SUBJECT: 1. Environmental Determination

- Subdivision Modification to defer the installation of water and sewer service connections
- 3. Tentative Map (P83-305) (APN: 225-230-46,59,60,66,67)

LUCATION: Southwest quadrant of I-5 and I-880

STAFF REPORT AMENDED 10-27-83 CITY PLANNING COMMISSION

NATOMAS EASTSIDE

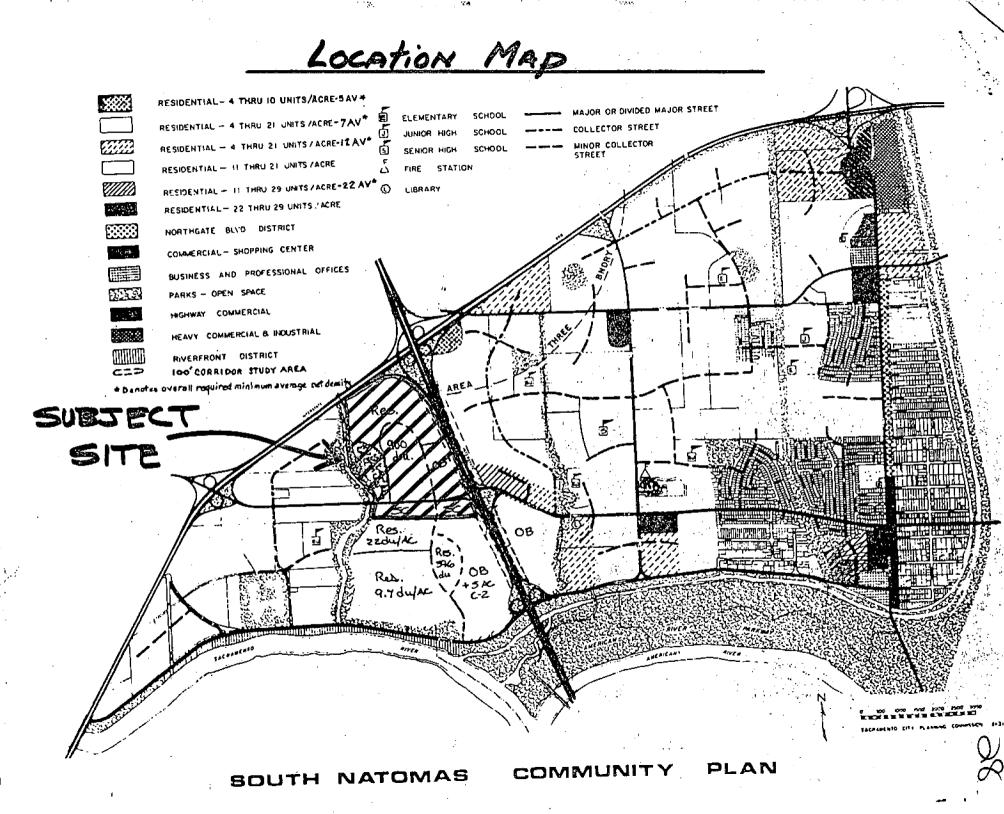
- 1. Decidate and improve West El Camino Avenue to a 120' r/w standard.
- 2. Dedicate and improve Natomas Oaks Drive (main north/south street) to 90' r/w standard from the south property line of the project to the first public street intersection north of W. El Camino Avenue.

- Dedicate and improve the remaining portion of Natomas Daks Drive to a 64' r/w standard (collector and bike lanes) to its intersection with W. El Camino.

- 4. Dedicate and improve loop to a 64' r/w standard (office access road).
- 5. Dedicate and improve expanded intersection at Natomas Oaks Drive and W. El Camino.

- 6. Offsite improvement and expansion of the bridge across the drainage canal and offsite pavement tapers will be required.
- 7. Few access points to individual parcels are indicated on the plan. For example, Parcels 8 and 9 total 606 residential units with but three points of access to public streets, and Parcel 10 has 481 units being served by one access point.

- 8. Dedicate and improve an east/west street north of W. El Camino connecting east and west Natomas Oaks Drive (loop) to a 64' r/w standard.
- 9. Provide a fully accuated traffic signal at the intersection of Natomas Oaks Drive and W. El Camino.
